Application for Licence Amendment

Licence Number	L8861/2014/1
Licence Holder	Karratha Recycling Pty Ltd
ACN	163 991 106
File Number	DER2014/002439-1~5
Premises	<p>Karratha Recycling Liquid Waste Facility Lot 111 Bedrock Turn and Lot 112 Exploration Drive GAP RIDGE WA 6714</p> <p>Legal description: Lot 111 on Deposited Plan 75061 Certificate of Title Volume 2813 Folio 263; and Lot 112 on Deposited Plan 75062 Certificate of Title Volume 2813 Folio 264</p> <p>As defined by the Premises map attached to the Revised Licence</p>
Date of Report	22/12/2020
Proposed Decision	Revised licence granted

Figure 1: Premises map

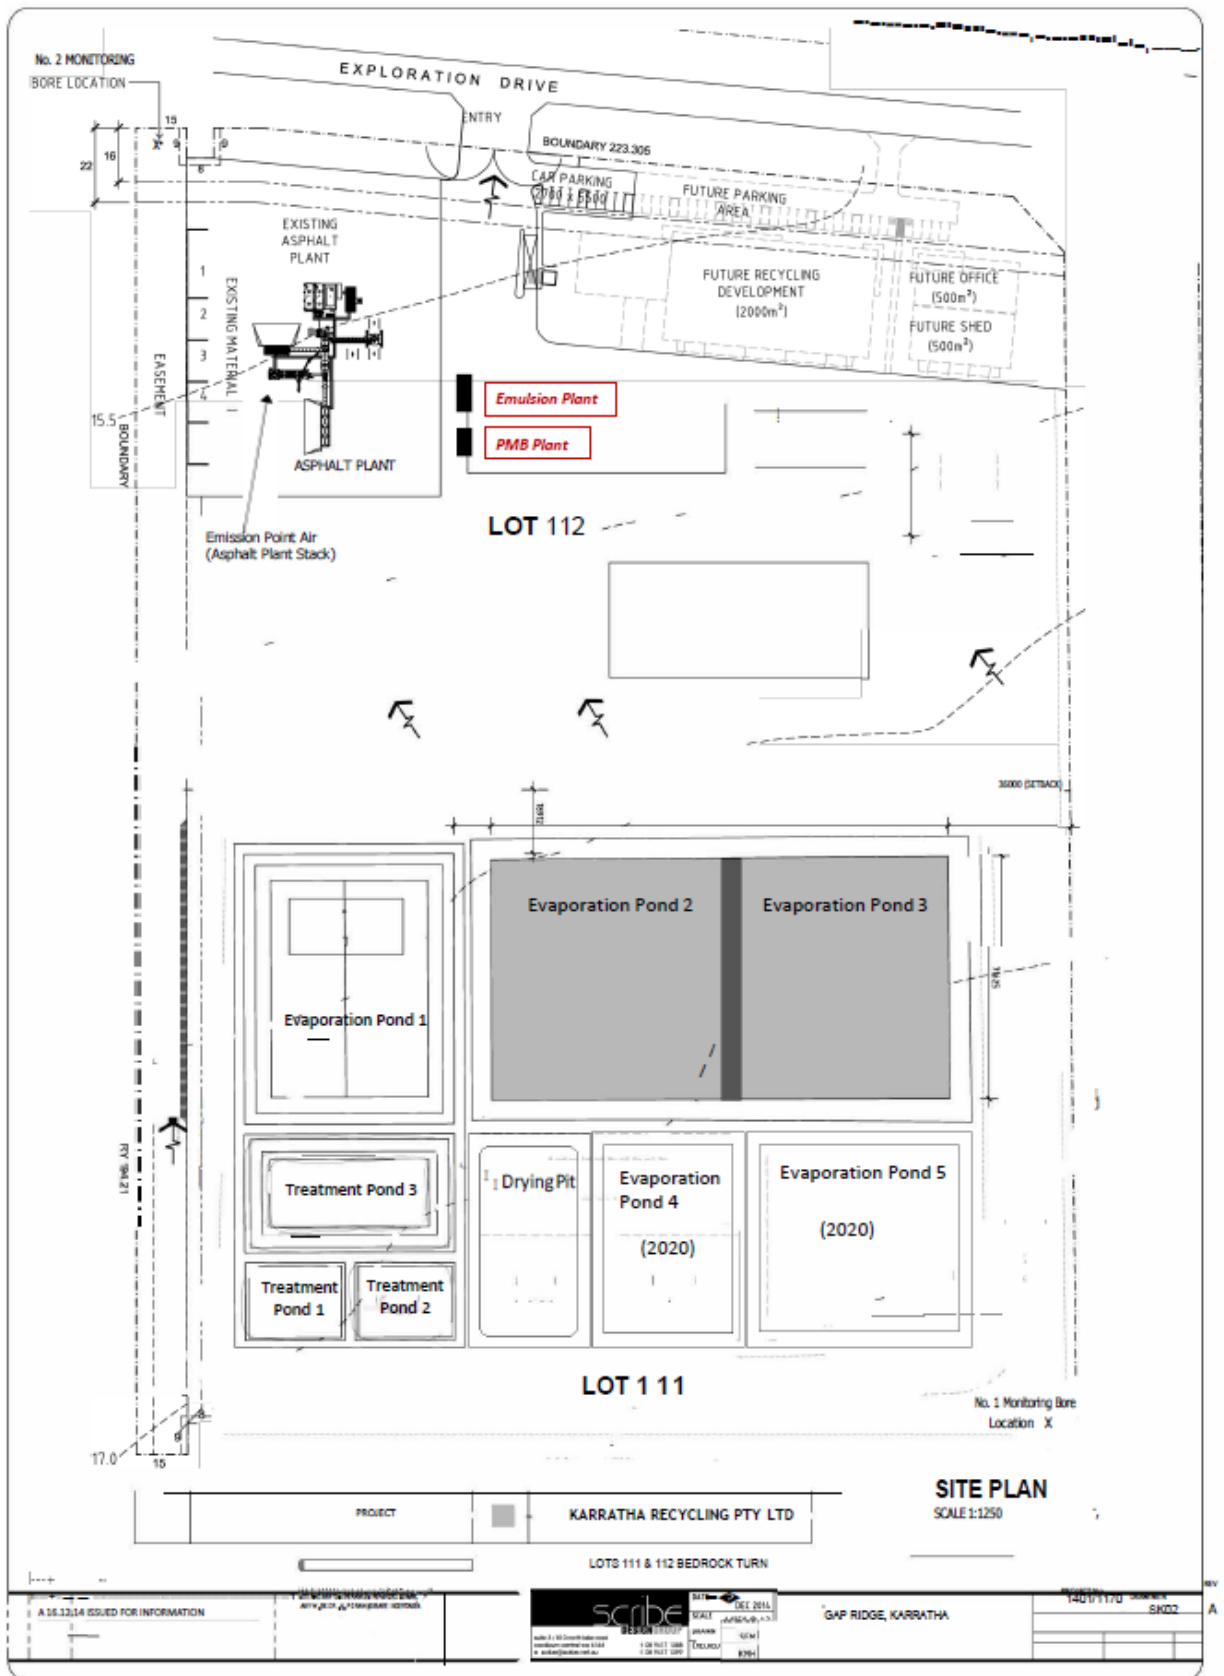
Infrastructure	Design and construction / installation requirements	Conformance with requirements
Evaporation pond 4 As defined on Figure 1	<ul style="list-style-type: none"> • Maximum storage capacity of 9,108 m³; • Maximum dimensions of 69 m in length, 43 m in width and 3 m in depth; • Compacted base of in-situ soil; • Lined with 2mm thick HDPE; • Lined in accordance with the specifications of Water Quality Protection Notice (WQPN) 26, <i>Liners for containing pollutants, using synthetic membranes</i> (Department of Water, August 2013); • Separation distance of at least 2 m must be maintained between the base of the HDPE liner and the highest wet season water table; • Perimeter of pond must be bunded; • Constructed to contain rainfall resulting from a 1 in 100 year storm event of 24 hours duration; and • Constructed to allow for a 500 mm 	<ul style="list-style-type: none"> • The ponds have been constructed to fall within the specified dimensions; • The in-situ soil of the pond areas was compacted; • The ponds have been lined with 2mm thick HDPE; • A CQA has been submitted for each pond to demonstrate that liner installation was completed with no material faults and as per the required specifications; • The water table at the ponds location varies between 9-10 mBGL according to sampling results obtained from an adjacent groundwater monitoring bore. The base of the HDPE liners installed are therefore approximately 7-8m from the water table; • The perimeter of the ponds are bunded utilising compacted in-situ soil excavated from the area of the

Infrastructure	Design and construction / installation requirements	Conformance with requirements
	freeboard to be maintained.	ponds;
Evaporation pond 5 As defined on Figure 1	<ul style="list-style-type: none"> • Maximum storage capacity of 15,525 m³; • Maximum dimensions of 72 m in length, 69 m in width and 3 m in depth; • Compacted base of in-situ soil; • Lined with 2mm thick HDPE; • Lined in accordance with the specifications of WQPN 26 (Department of Water, August 2013) • Separation distance of at least 2 m must be maintained between the base of the HDPE liner and the highest wet season water table; • Perimeter of pond must be bunded; • Constructed to contain rainfall resulting from a 1 in 100 year storm event of 24 hours duration; and • Constructed to allow for a 500 mm freeboard to be maintained. 	<ul style="list-style-type: none"> • The ponds capacity to contain rainfall resulting from a 1 in 100 year storm event of 24hrs duration, and to allow for a 500 mm freeboard to be maintained, have been demonstrated through water balance equations submitted in support of this application.
